File #: 17-522, **Version:** 1

Discuss and consider an appeal of the Non-Residential and Multifamily Design Standards and articulation requirements for a proposed diesel mechanic shop addressed at 556 Danken Lane in the "C-3" Commercial District.

Case No.: CS-17-014

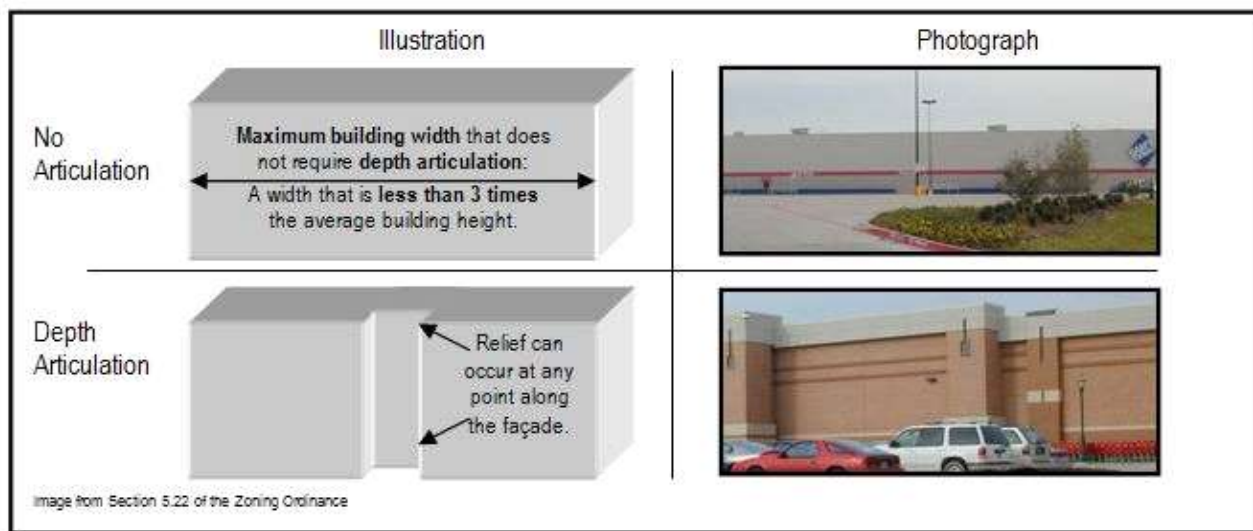
The horizontal articulation requirements for the proposed building only apply to the building facades facing Danken Lane and Executive Drive. The front facade as proposed would not meet the minimum horizontal articulation requirements. The width of the front façade is 180 feet with an average height of 20 feet. According to the design standards, no portion of the façade shall extend for more than three times the average height (60 feet) without depth articulation. To meet the design standards, there would need to be a minimum of 2 horizontal offsets (relief) at least 3 feet deep (15% of the average building height), extending a width of at least 18 feet (10% of the width of the building façade), positioned on the façade so that no portion of the façade would extend for more than 60 feet without an offset. The required offsets could be an inset or a protrusion as depicted in the following illustration:

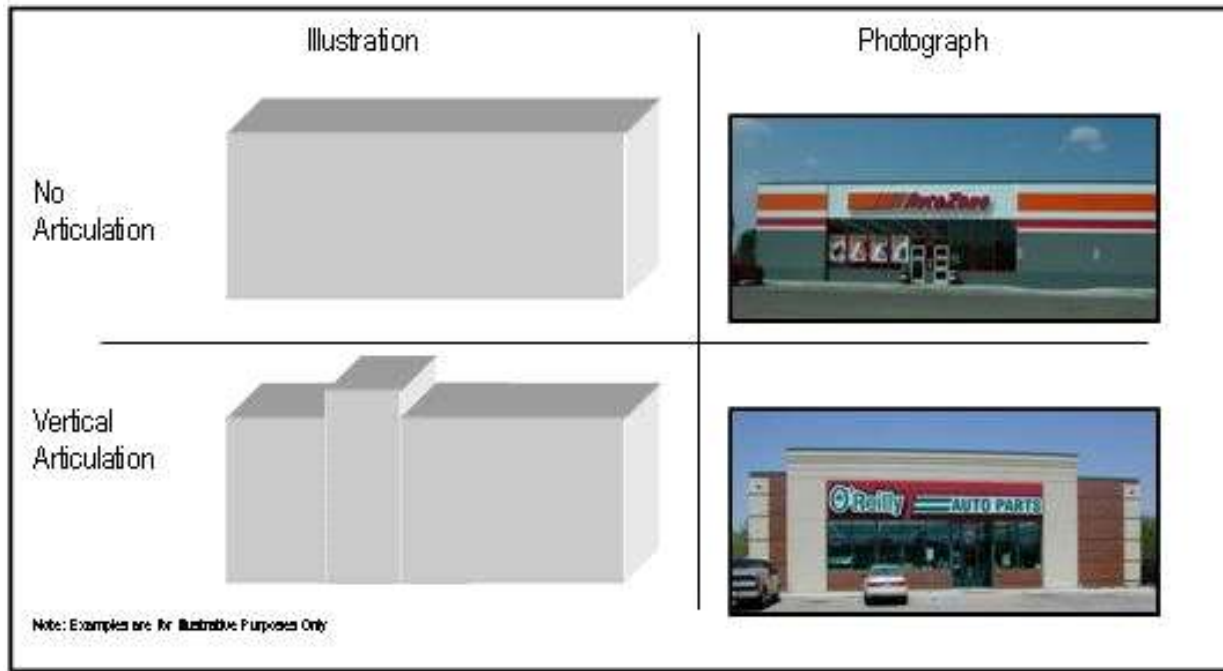
The Vertical articulation requirements for the proposed building also only apply to the building facades facing Danken Lane and Executive Drive. The front facade as proposed would not meet the minimum vertical articulation requirements. The width of the front façade is 180 feet with an average height of 20 feet. According to the design standards, no portion of the façade shall extend for more than three times the average height (60 feet) without a change in façade elevation. To meet the design standards, there would need to be a minimum of 2 vertical offsets (relief) with a change in elevation height of at least 3 feet (15% of the average building height), extending a width of at least 18 feet (10% of the width of the building façade), positioned on the façade so that no portion of the

façade would extend for more than 60 feet without an offset. The offsets can be of varying heights as long as the minimal standard is satisfied as depicted in the following illustration:
